Product Change Notice

PCN#: EE-PCN15011M

Shipping box and external and internal label update for Eaton Electronics Division products.

NEW-OUTER CARTON LABEL

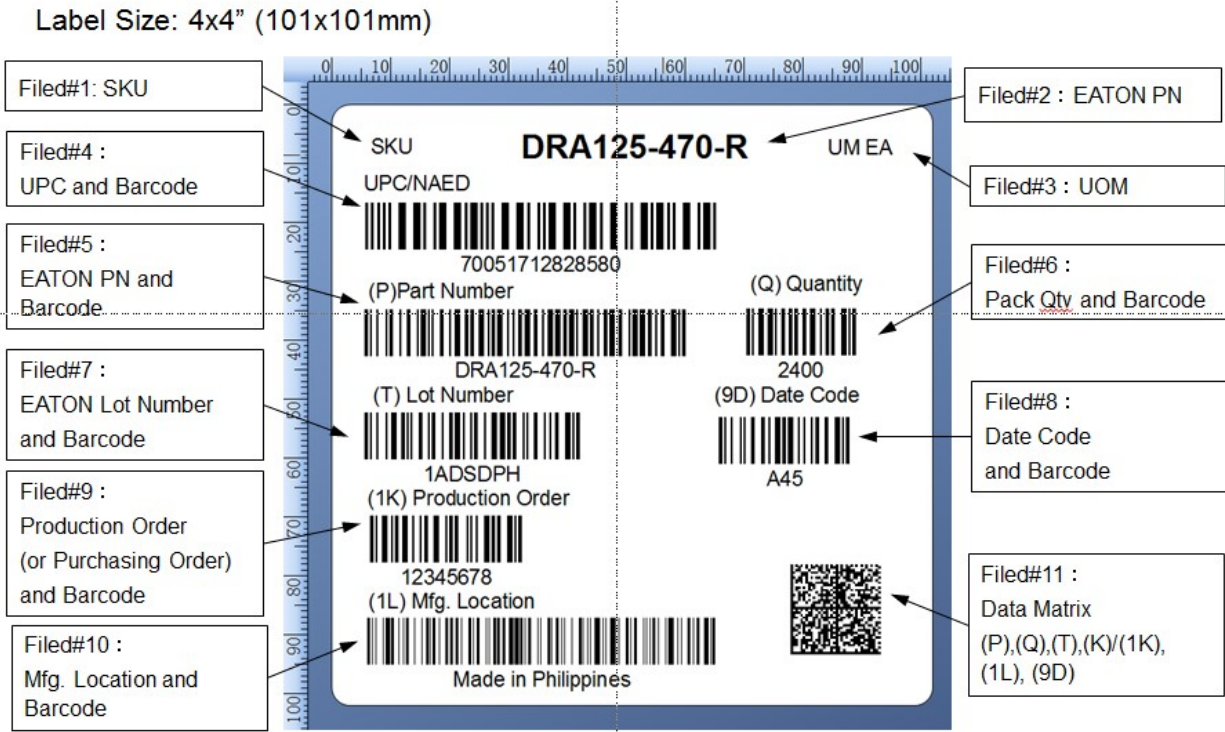
Amend: The format of the original Eaton labels has changed---Please see page 3 and 4 for a comparison of the new Eaton labels to the original Eaton labels.

Additional change: The "Lot Number" listed on the outer label is now the "Date Code" reference. Component marking change detail added (See page 5).

NEW---INNER CARTON LABEL

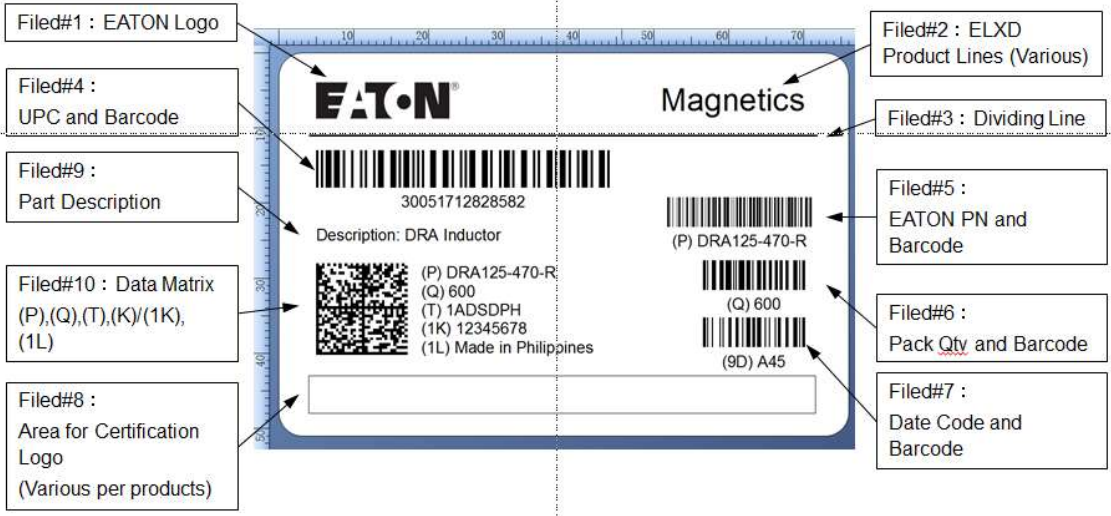
Label Size: 3x2" (76x51mm) preferred.
 Optional: 70x36mm, 66x37mm, or other sizes approved by ELXD.

Circuit protection

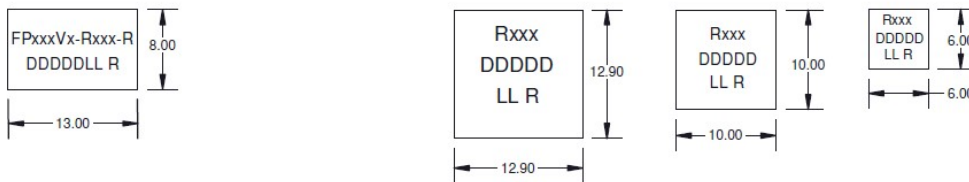
No impact. Date code is not marked on circuit protection product.
